<b>ROLAND SERVICE INFORMATION</b>	NO.	100222
	DATE	August 4, 1984

PRODUCT AFFECTED: JUNO-106

TO SERVICE ENGINEERS: SUBJECT  
COUNTERMEASURE TO MEMORY BACK UP BATTERY

<b>ROLAND SERVICE INFORMATION</b>	NO	100229
	DATE	Dec. 21, 1984

JUNO-106 MODIFICATION

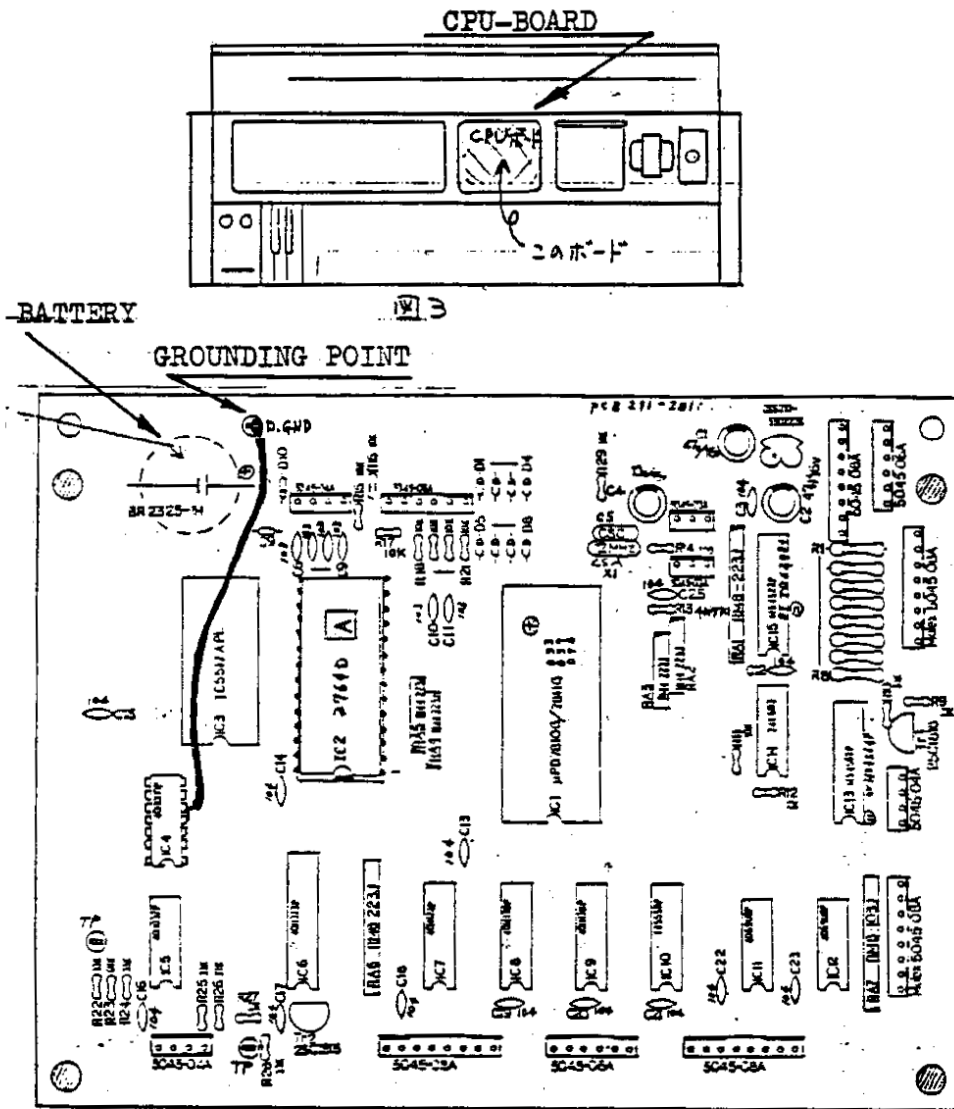
It was found that JUNO-106 is likely to break memory data in a short period as IC-4 40H000P on CPU BOARD draws a variance current ranging 250 micro ampere to zero.

The "floating" inputs (pins 4 and 5) of the unused section of IC-4 40H000P are the cause of this problem. The solution is that they should be connected to ground point by using a jumper wire. Please refer to the attached drawing.

NOTE: Firstly, connect a jumper wire to above ground point to prevent breaking IC from happening on, and then, connect the jumper wire to pins 4 and 5 of IC-4.

Pins 4 and 5 must be connected to grounding point by using a jumper wire.

- STEP-1: Check whether the battery voltage is more than 2.8V or not.
- STEP-2: If the battery voltage is less than 2.8V, please replace the battery with new one and then take above modification to CPU BOARD.
- STEP-3: If the battery voltage is more than 2.8V, you do not need to replace the battery but need to take the modification.
